### **REMARKS/ARGUMENTS**

Appl. No. 09/742,036  
Amdt. dated 08/21/2003  
Reply to Office action of 07/02/2003

【図 7】

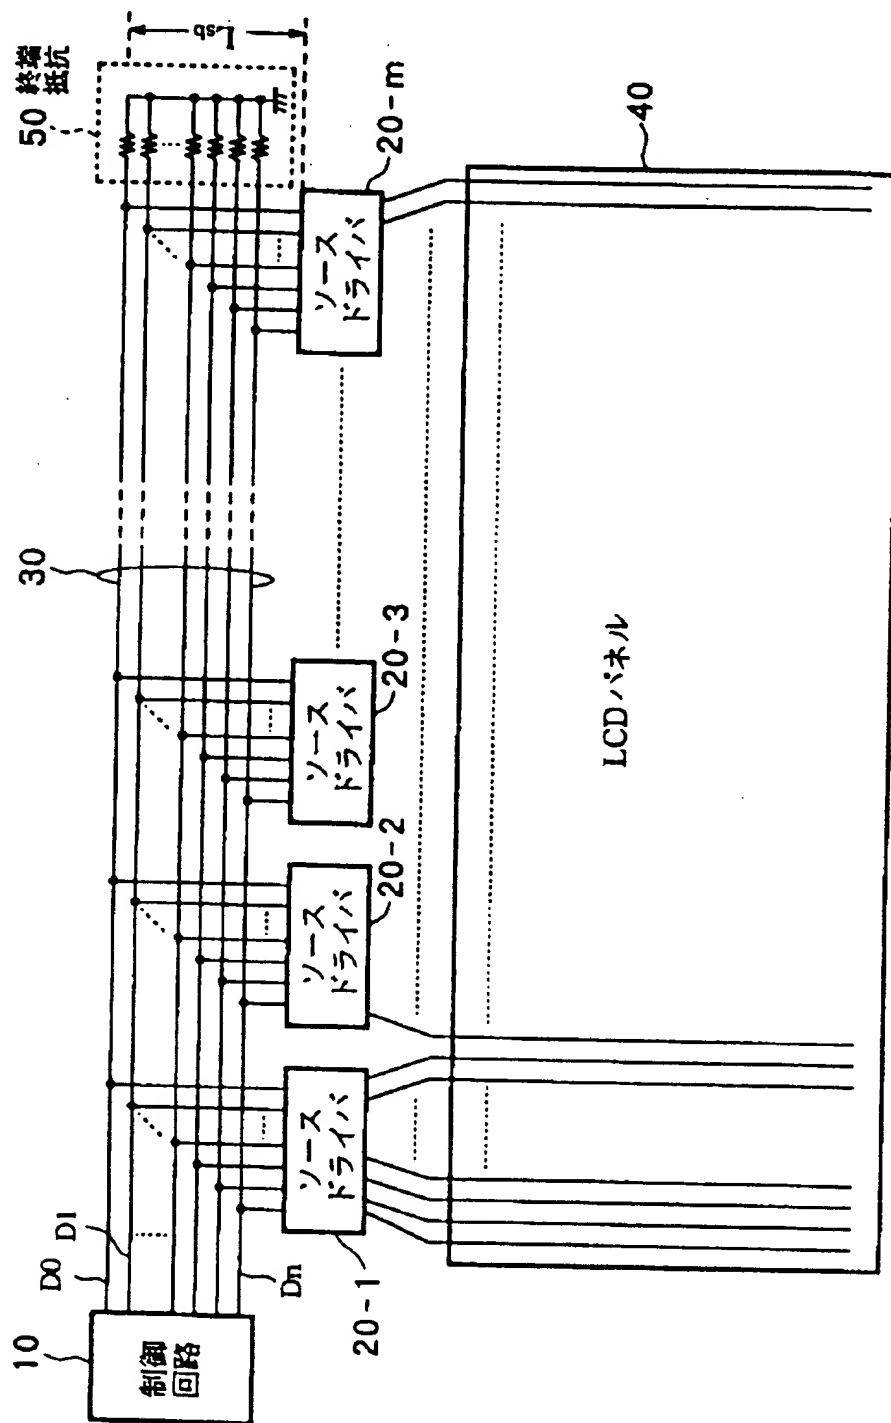
The Examiner states that Figure 7-9 should be designated by a legend such as --Prior Art-- because only that which is old is illustrated. These Figures have been so amended. The Examiner's approval of the drawing changes is respectfully requested.

PRIOR ART

【図 9】

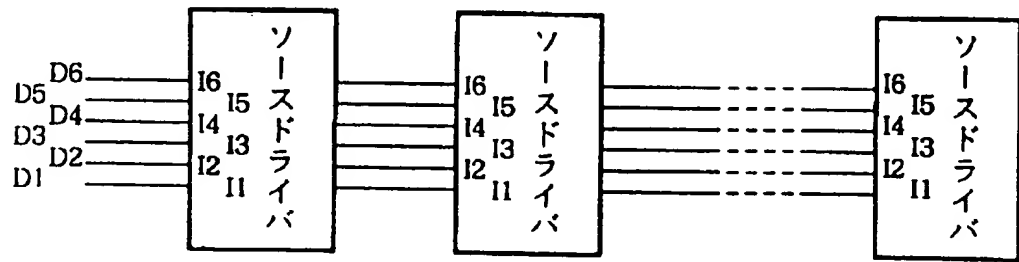
We cannot agree. Dingwall shows, in the Figure 4 recited by the Examiner, the same technology shown in Figure 9 of the present application, which is acknowledged prior art. This only works where the inputs to the chip are on one of the long dimensions of the chip and the outputs are on the short dimensions of the chip (not shown in Figure 4 of Dingwall) which is not the case here. Because of the high switching frequency of the output lines, it is not practical to crowd them to have the inputs come along the short end of the chip and the outputs come along the long end of the chip in the present invention. These lines need greater spacing than this would provide. Furthermore, Mical is even further from the present invention. At top of col. 6 of Mical, is a description of a resolution-enhancing subsystem which includes a crossover unit 151 for selectively transposing part of the Px signals, first and second delay registers A and B couple to the crossover unit for generating previous column signals. Thus, although the reference mentions a cross-over unit, it is clear that this is for a completely different purpose and totally unrelated to the present invention. With respect to Cha, it is respectfully submitted that the wiring 30 and the wiring 20 are on different circuit boards which are attached to the integrated circuit chip 12 in Figure 1 and therefore comprise, in effect, a multilevel wiring, which is the problem sought to be overcome by the present invention. It should be noted that Claim 11 recites a wiring substrate having a single level of wiring thereon.

PRIOR ART
